Detailed Review of FEMA CCAMP for City of Malibu

The City Of Malibu
23825 Stuart Ranch Road
Malibu, CA 90165

M&N File: 9937

Transect 35 (873) Profile and Runup Parameters

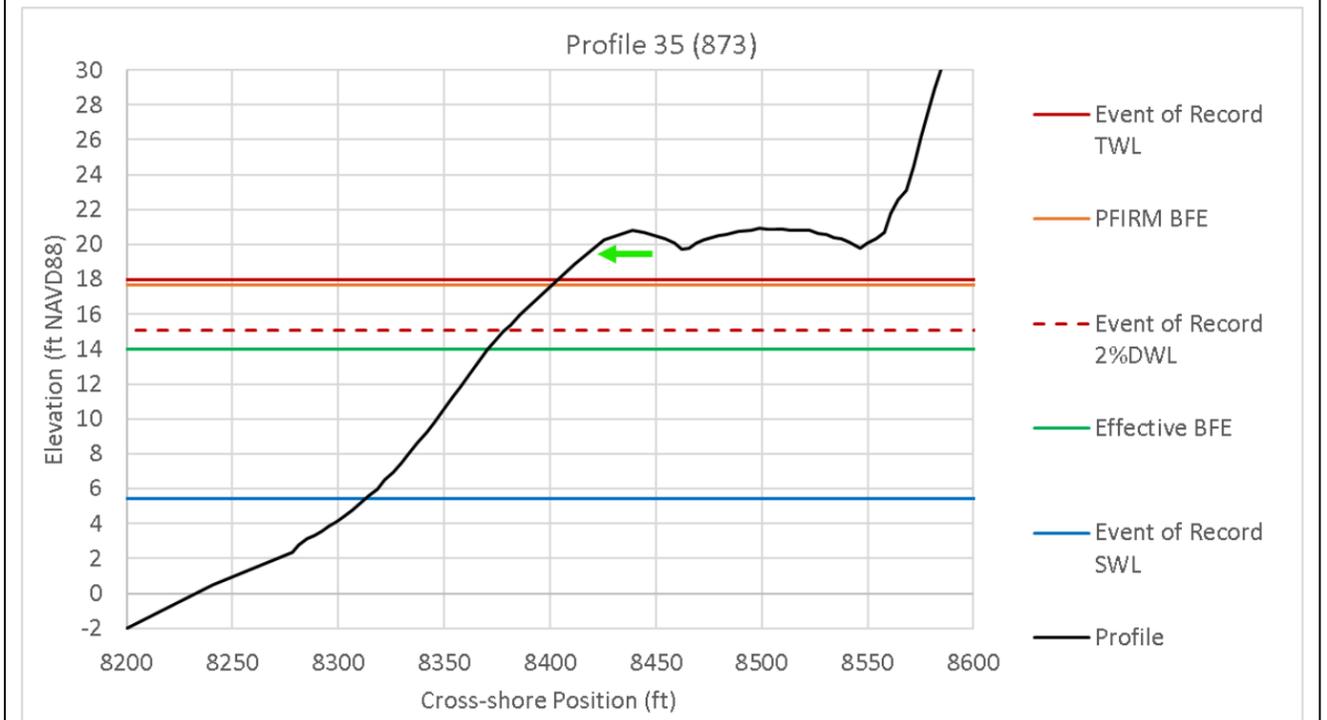
- ▶ Despite differences in shore features and wave parameters the upcoast and downcoast transect BFEs only differ by +/-1 ft.
 - Transect 34: 17 ft; and Transect 36: 19 ft

The BFE is based on a wave encountering a sandy beach that slopes up to PCH. Variations in coastal protection and structures throughout this zone could influence the BFE for specific parcels in this zone. If the DIM Method were used instead of Stockdon, the BFE would be several feet lower.

Transect 36 (870) Profile and Runup Parameters

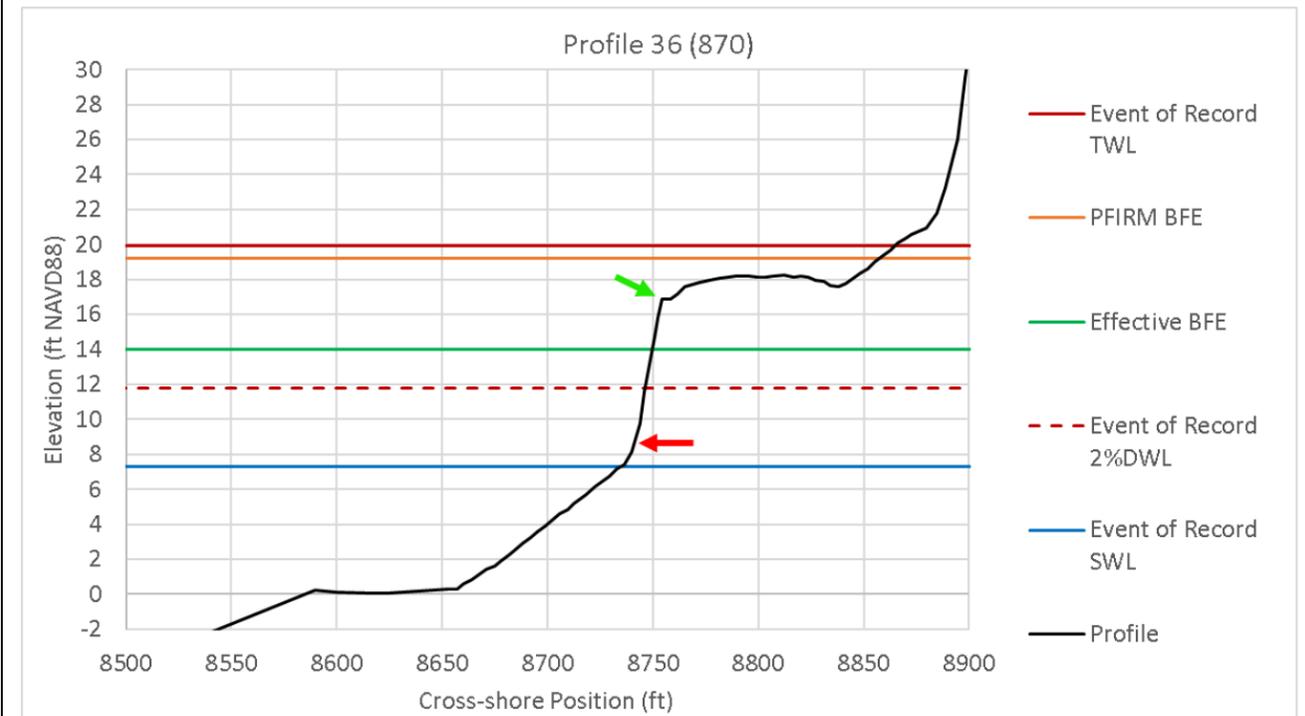
- ▶ Wave input parameters may not adequately characterize reduced nearshore wave heights due to oblique approach angles and influence of nearshore bathymetric features (i.e., headland).

The shore type varies significantly within this reach. Addition of a transect to capture the headland versus sandy beach may be warranted. Adjustments for oblique wave angle, slope roughness coefficient in the TAW runup calculations could reduce BFE at this transect.

Transect 38 (859) Profile and Runup Parameters

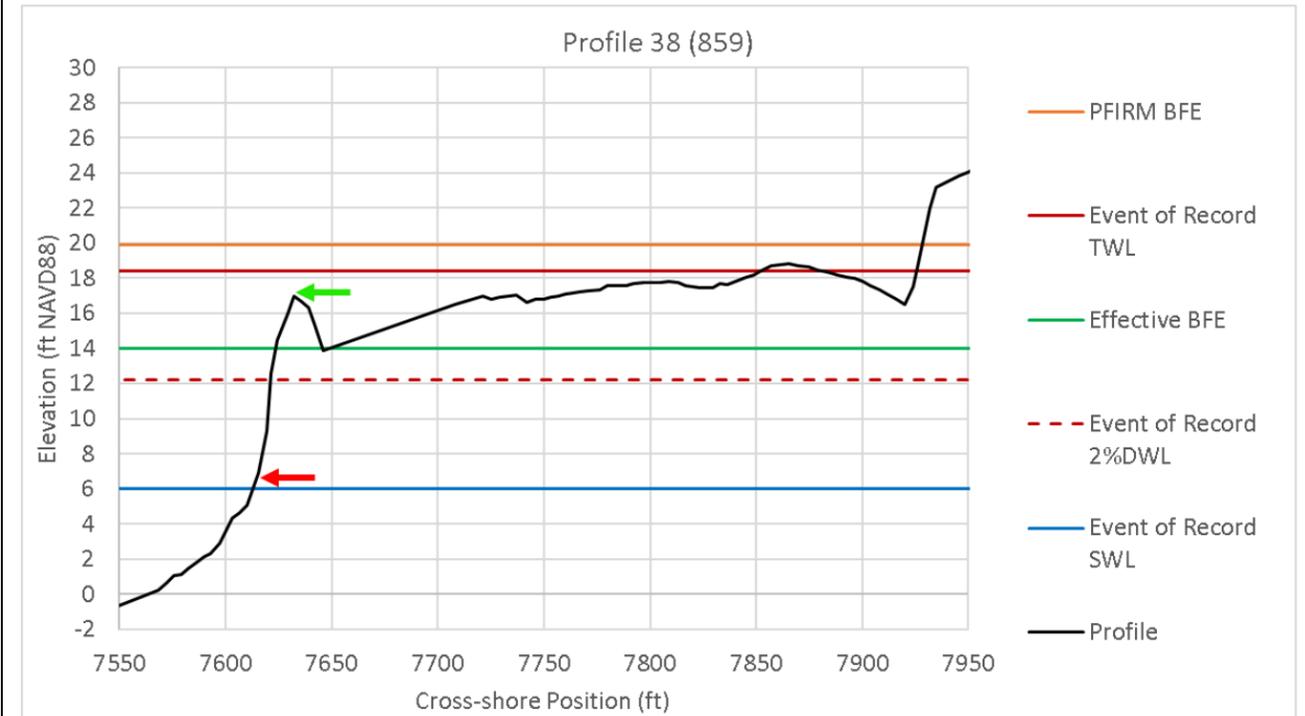
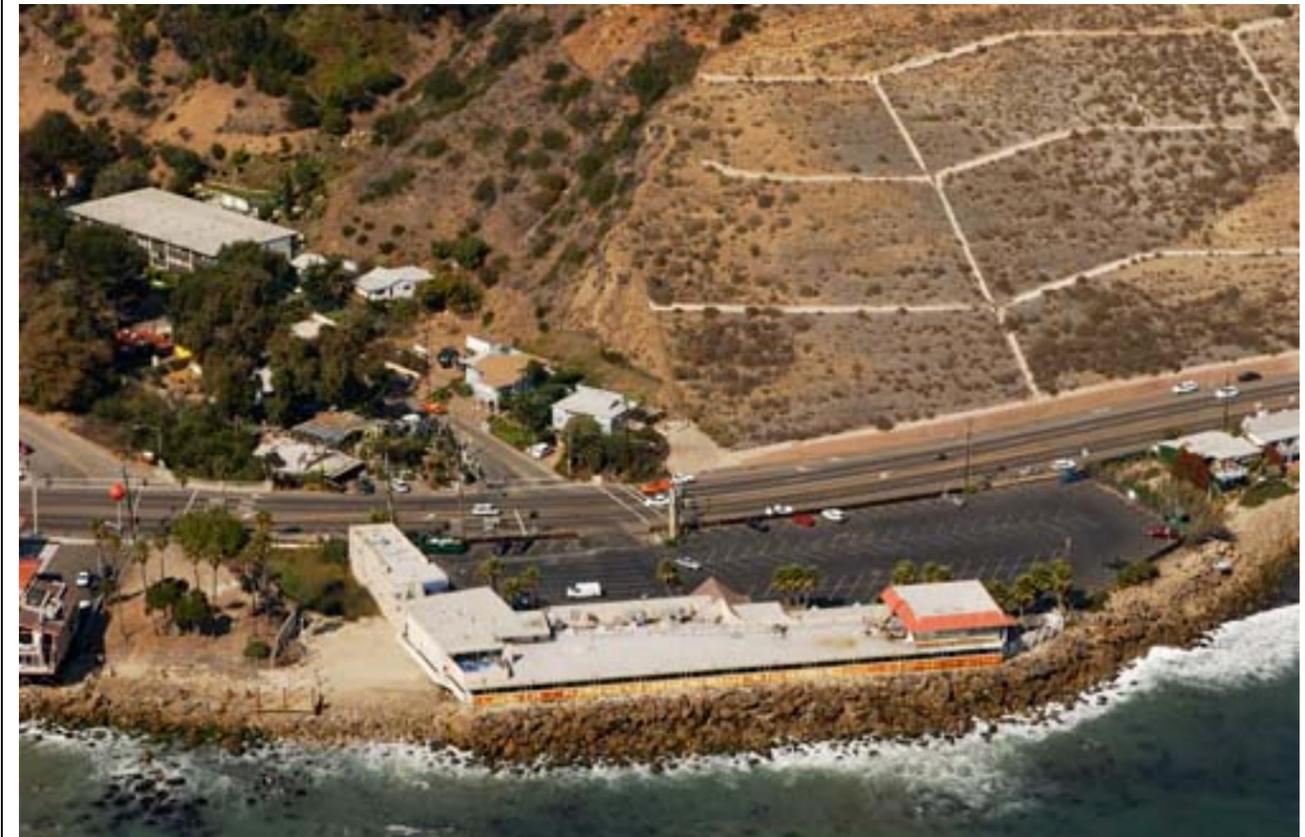
- ▶ BFE is based on intact condition calculations is 2 ft higher than the event of record, and is not justified by the TWL calculations
- ▶ Steep beach slope with DWL2% above toe; $TWL_{TAW} > TWL_{DIM}$ therefore, TAW runup method is appropriate for event of record.
- ▶ Event of record parameters vary from upcoast and downcoast transects.
 - Transect 37: 3/2/83 11:00, SWL = 5.4 ft, H_o = 14.4 ft, T_p = 15.9 sec, Toe el. = n/a
 - Transect 39: 3/2/83 11:00, SWL = 5.4 ft, H_o = 13.4 ft, T_p = 15.9 sec, Toe el. = 15.1 ft
- ▶ BFEs are lower for upcoast and downcoast transects, where Stockdon Method was used for calculating runup. At this transect, there is no beach and waves encounter the steep revetment slope, which explains the different runup method used.
 - Transect 37: 18 ft
 - Transect 39: 13 ft

The BFE is likely overestimated in this zone and not backed up by the TWL calculations in the IDS report. An appeal may be warranted to revise the BFE to match the TWL calculation for an intact revetment.

Transect 39 (854) Profile and Runup Parameters

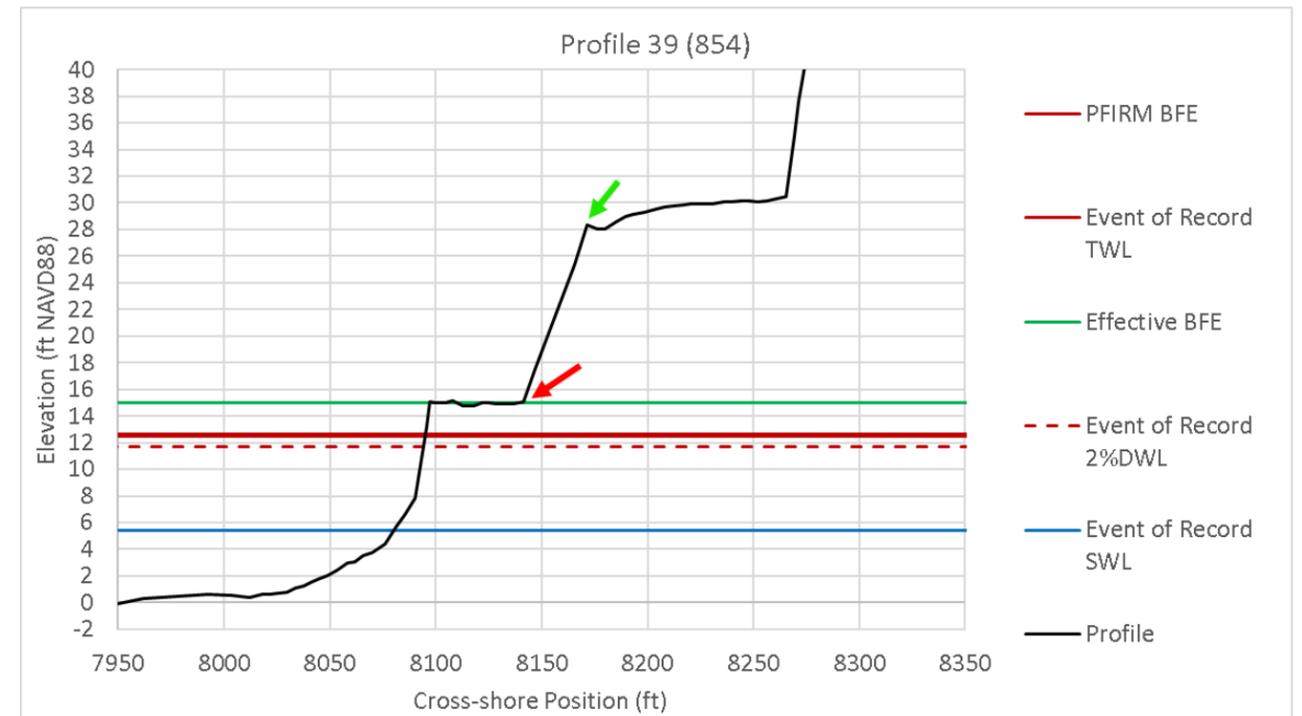
- ▶ Shoreline conditions and transect features like the toe and crest are not correctly represented. If transect crest & toe were defined in a manner consistent with adjacent transects a different runup method (probably TAW) would have been applied, resulting in a BFE similar to adjacent transects.
- ▶ Event of record parameters vary from upcoast and downcoast transects.
 - Transect 38: 3/1/83 23:00, SWL = 6.0 ft, H_o = 14.2 ft, T_p = 11.9 sec, Toe el. = 6.9 ft
 - Transect 40: 1/29/83 9:00, SWL = 7.3 ft, H_o = 8.4 ft, T_p = 11.9 sec, Toe el. = 8.3 ft
- ▶ BFEs are significantly higher at the upcoast and downcoast transects even though their shore orientation and exposure is not significantly different.
 - Transect 38: 20 ft
 - Transect 40: 21 ft

The BFE is likely underestimated in this zone due to how the transect features (toe and crest) are characterized. The DIM runup method was exclusively applied to this transect and is not consistent with adjacent transects. Adjacent transects have similar orientation and exposure with a much higher BFE based on runup calculation using the TAW method.

Transect 40 (846) Profile and Runup Parameters

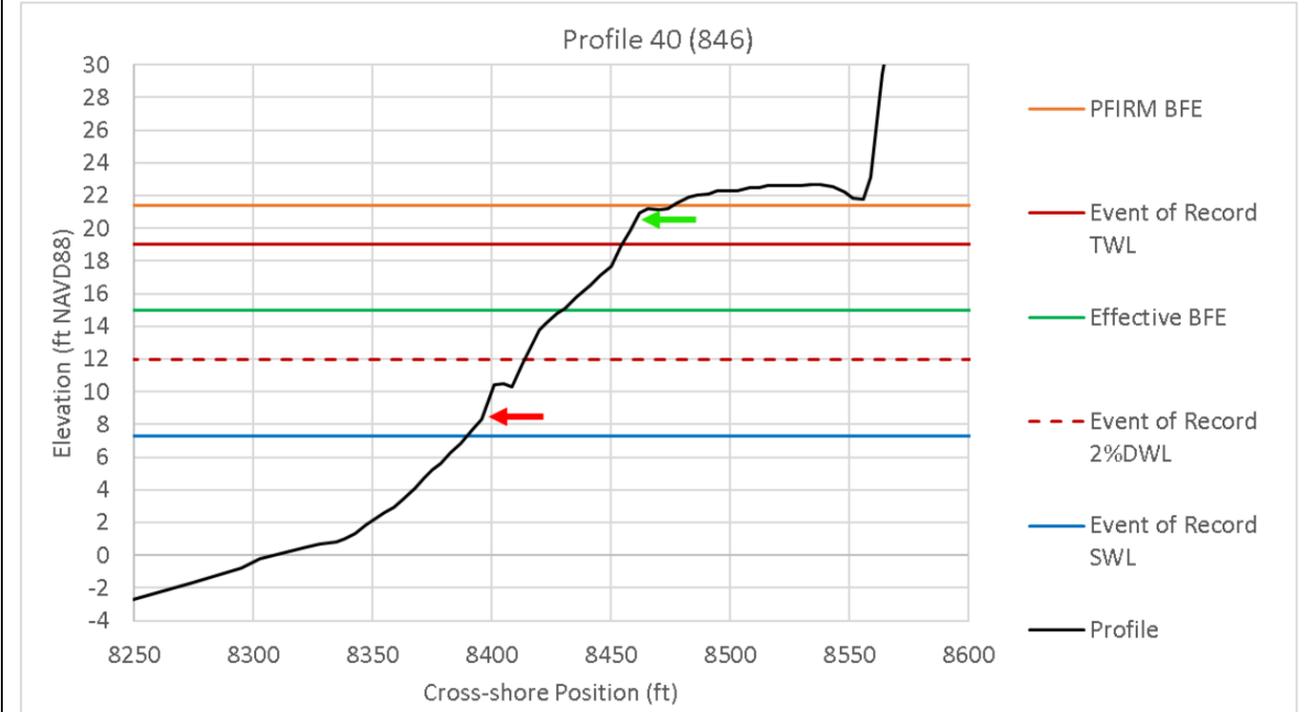
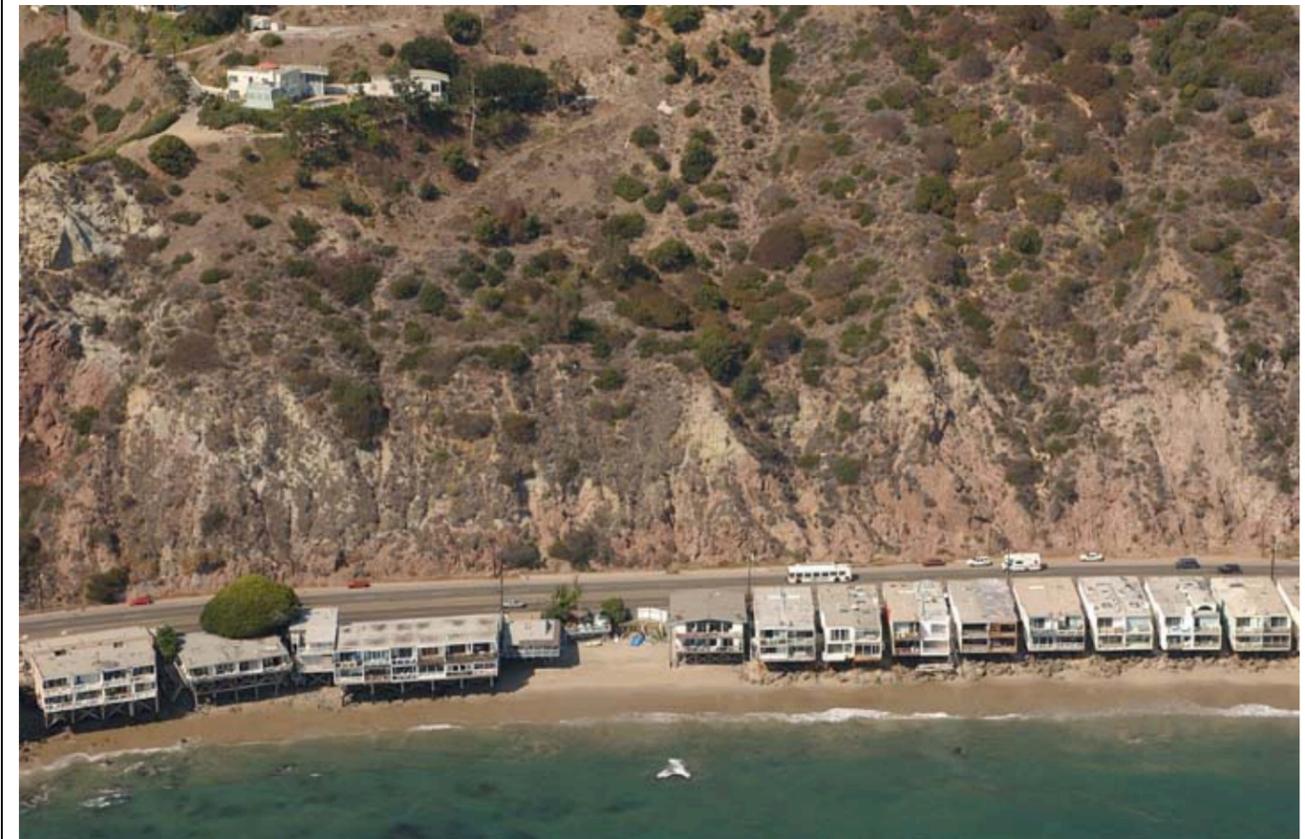
- Transect 41: 25 ft
- ▶ No roughness factor is assumed for the TAW runup calculations, which may overestimate some of the TWL calculations. Although the cobble and riprap is not a flood protection structure, it is persistent in the nearshore and unlikely to be carried offshore (as assumed "removed") during the 1% event. A composite roughness factor should be applied to the TAW runup calculations.

The BFE may be overestimated in this zone. The TAW runup calculations do not consider a roughness factor that can reduce the calculated TWL by several feet. The BFE considers a wave encountering a steep bluff behind the residential beachfront parcels. Variations in coastal protection and structures throughout this zone could influence the BFE for specific parcels.

Transect 42 (824) Profile and Runup Parameters

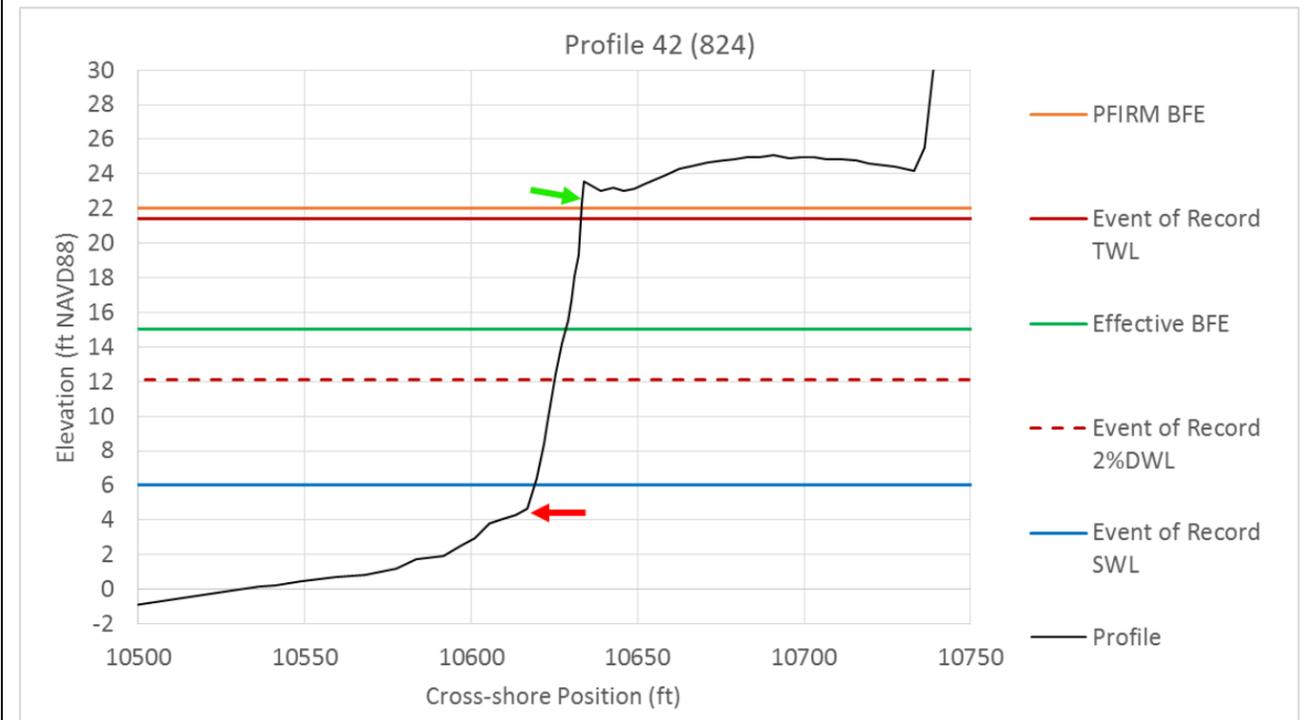
- ▶ Same roughness value applied in both intact and failed TWL calculations.

The transect used to calculate the BFE characterizes a revetment that is not representative of conditions in the rest of the zone, particularly where structures are located. The BFE could vary at the residential parcels depending on their structural features and transect geometry.
